STATE OF UTAH
DEPARTMENT OF NATURAL RESOURCES
DIVISION OF OIL, GAS AND MINING

APPLICATION FOR PERMIT TO DRILL		5. MINERAL LEASE NO: ML-21330	6. SURFACE: State
1A. TYPE OF WORK: DRILL <input checked="" type="checkbox"/> REENTER <input type="checkbox"/> DEEPEN <input type="checkbox"/>		7. IF INDIAN, ALLOTTEE OR TRIBE NAME:

2. NAME OF OPERATOR: KERR MCGEE OIL & GAS ONSHORE L.P.		9. WELL NAME and NUMBER: NBU 1021-29L	
3. ADDRESS OF OPERATOR: 1368 S 1200 E CITY VERNAL STATE UT ZIP 84078		PHONE NUMBER: (435) 781-7024	10. FIELD AND POOL, OR WILDCAT: NATURAL BUTTES

**WORKSHEET
APPLICATION FOR PERMIT TO DRILL**

FIGURE #2

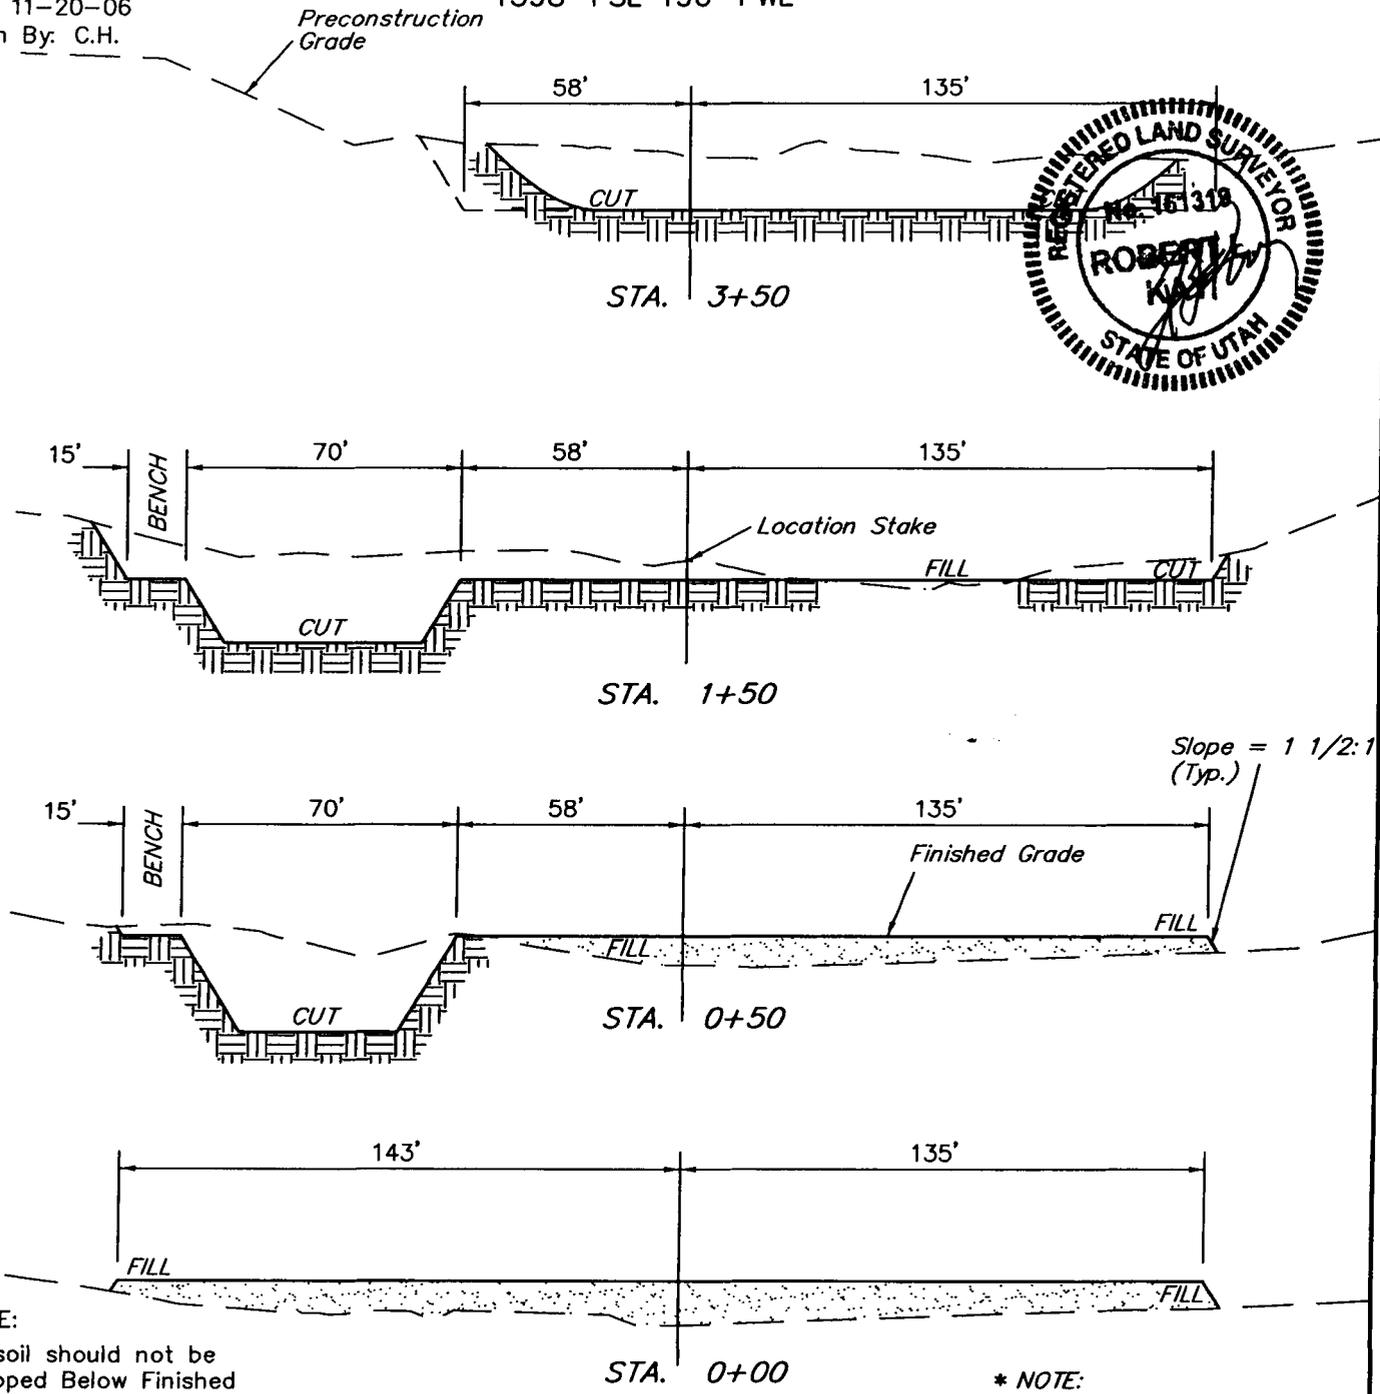
The proposed reserve pit is 70' x 150' x 10' deep located in a cut on the south east corner of the location. A 20 mil liner with a felt sub-liner is planned by Kerr McGee.

Category	Condition
Pits	A synthetic liner with a minimum thickness of 20 mils with a felt subliner shall be properly installed and maintained in the reserve pit.
Surface	Drainages adjacent to the proposed pad shall be diverted around the location.
